METAL PANEL AMENDMENTS

METAL STAIR OMISSION

GREYSTAR

CONSENTED GA ELEVATION - WEST ELEVATION CF

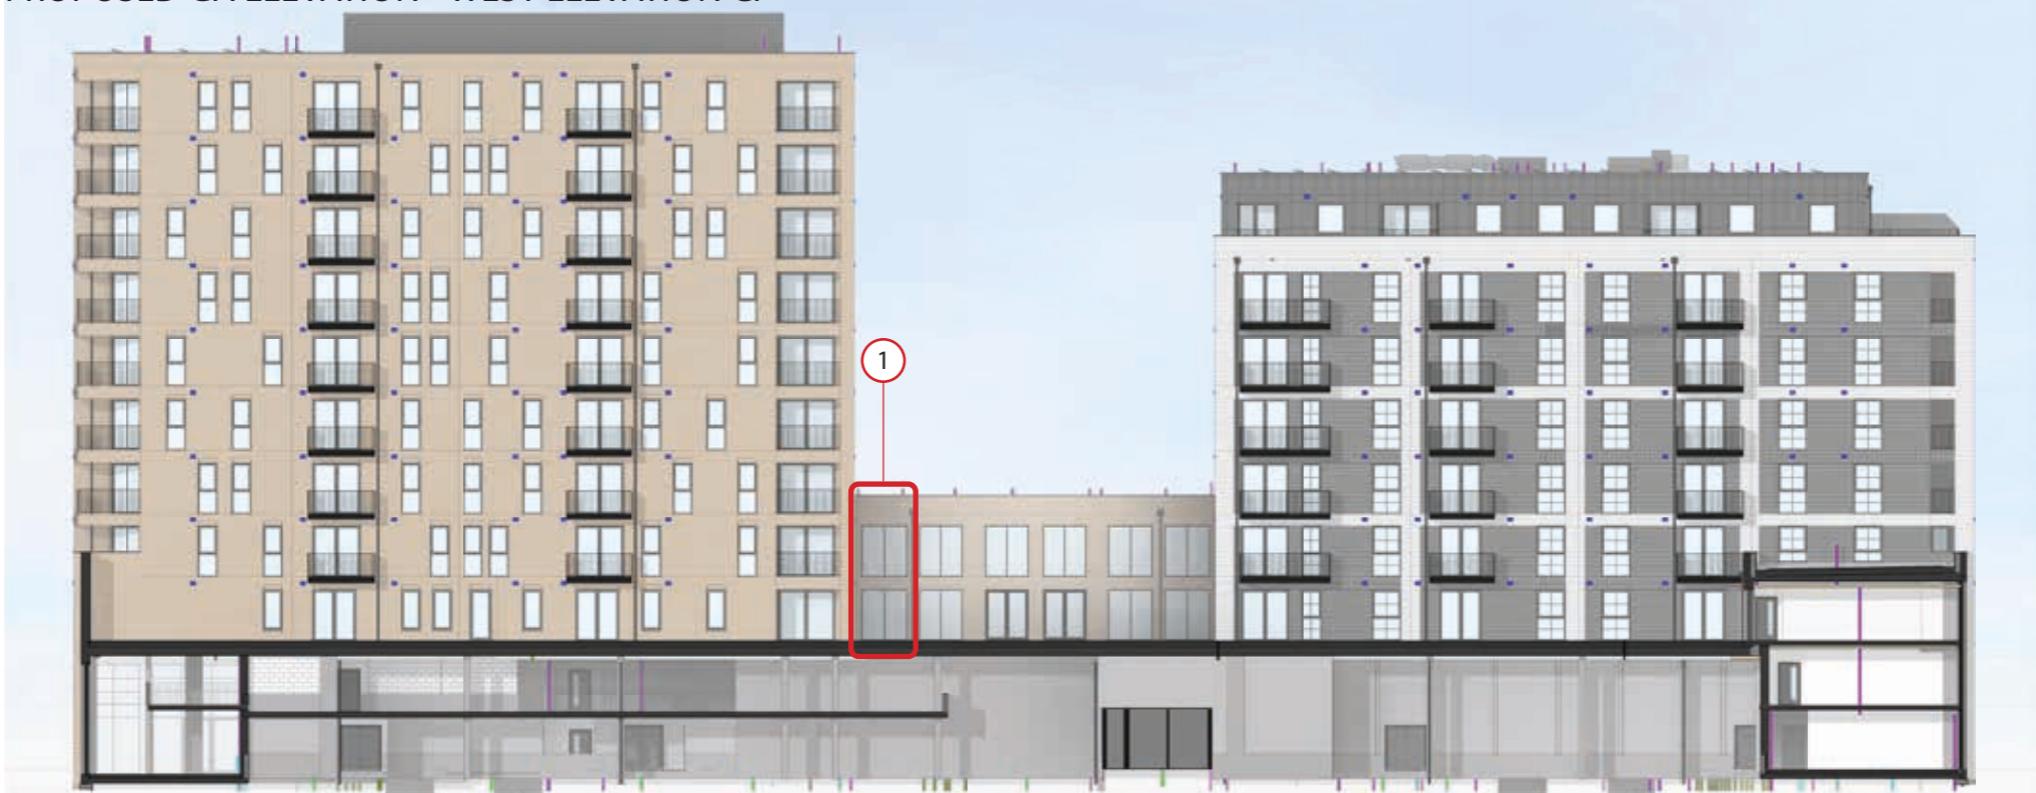
1. Originally in place to provide privacy, it is realised that these windows no longer provide that function and so can be made clear glass to bring as much light into the circulations areas as possible.

CONSENTED GA ELEVATION - EAST ELEVATION PODIUM

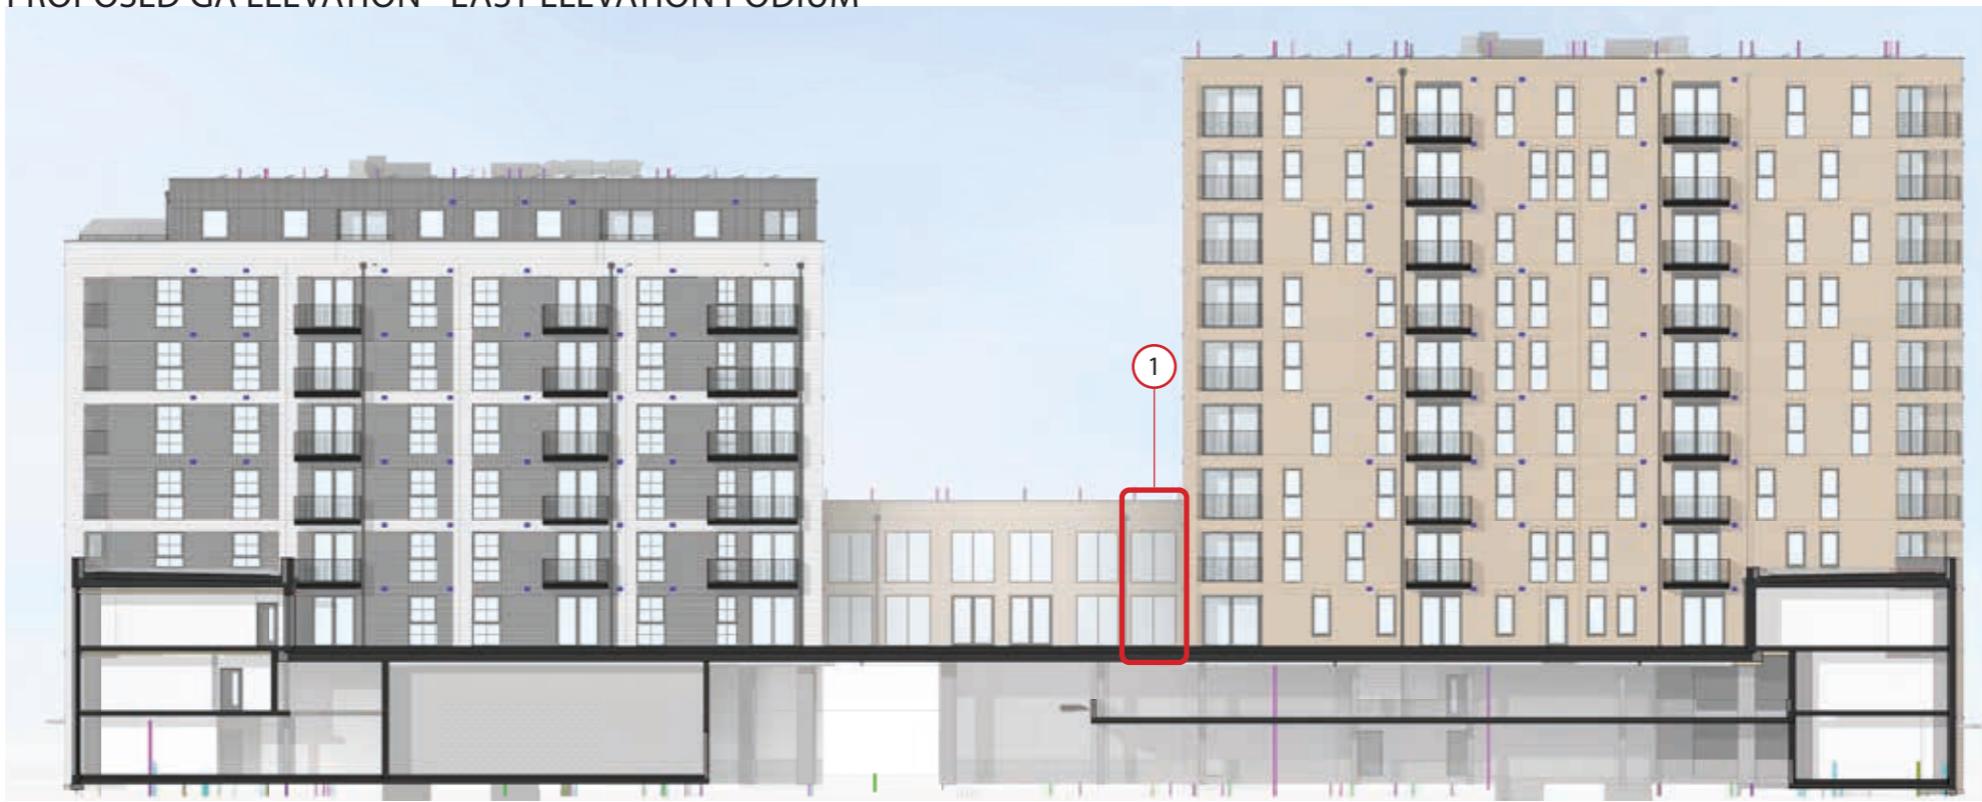
1. Originally in place to provide privacy, it is realised that these windows no longer provide that function and so can be made clear glass to bring as much light into the circulations areas as possible.

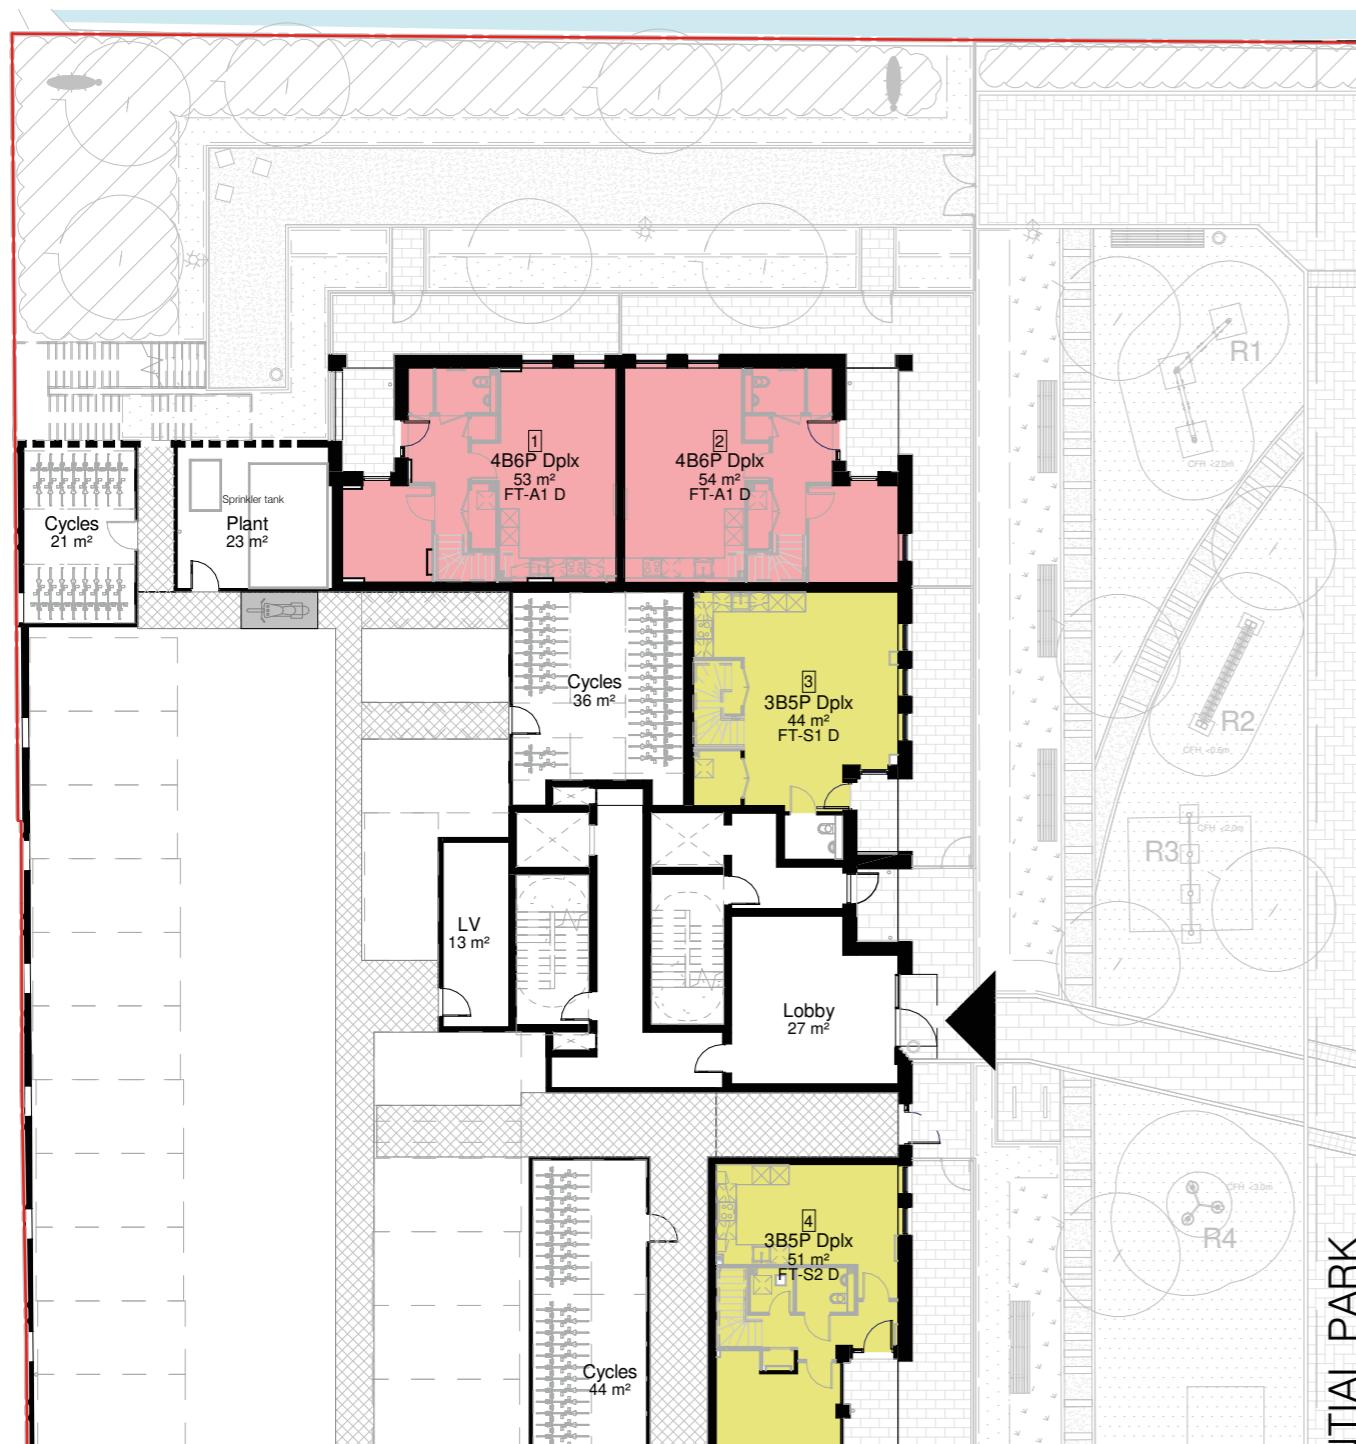
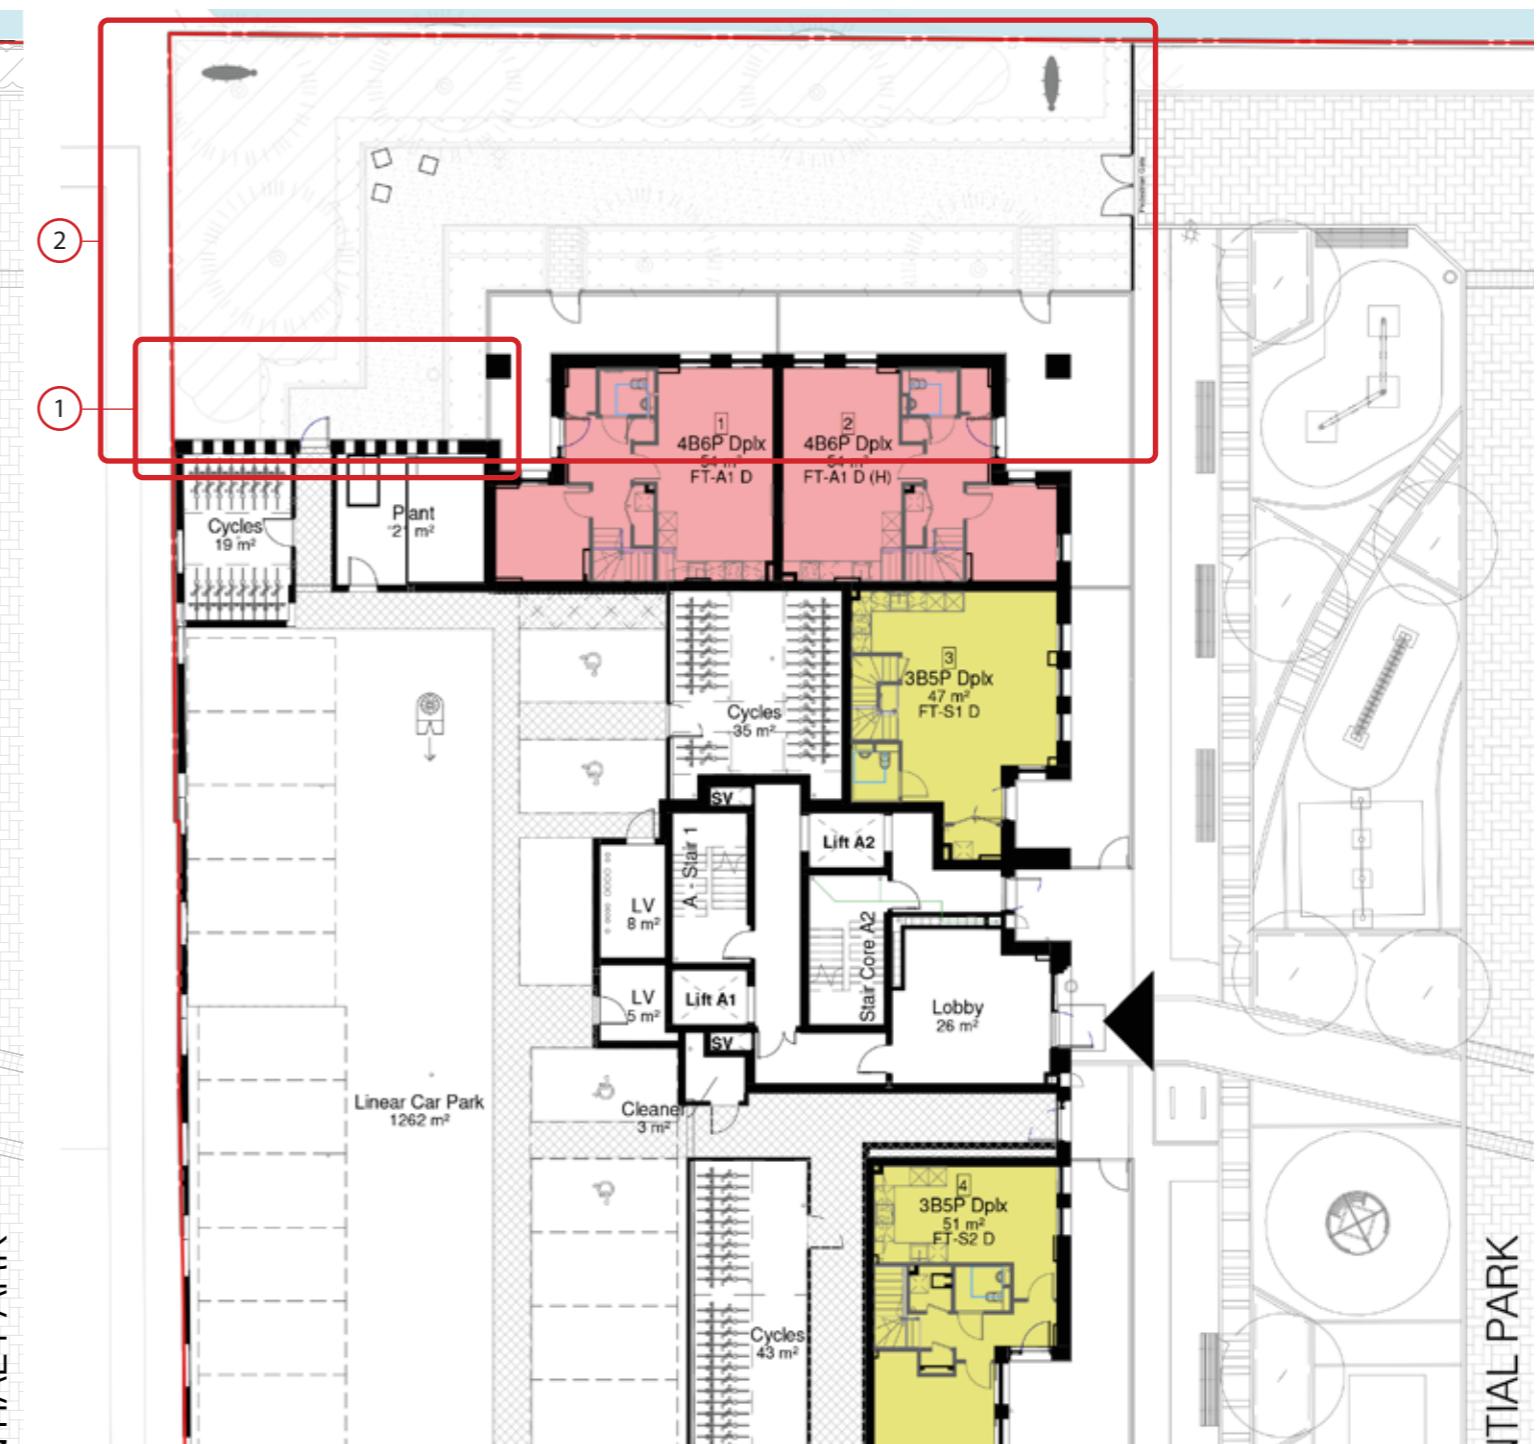
- Following the review of the access and security proposals, the secure by design officer supports the omission of the external stair case between the block A podium and the canal. They have expressed concerns about the security of the homes, and the likelihood that the stair will attract antisocial behaviour. If the stair were to remain they have stated that it would have to be practically caged to provide sufficient security, and this simply erodes the welcoming domestic environment that we have fought so hard to establish. Fire Escape door to remain.
- The Landscape has been amended as a result of metal stair omission.
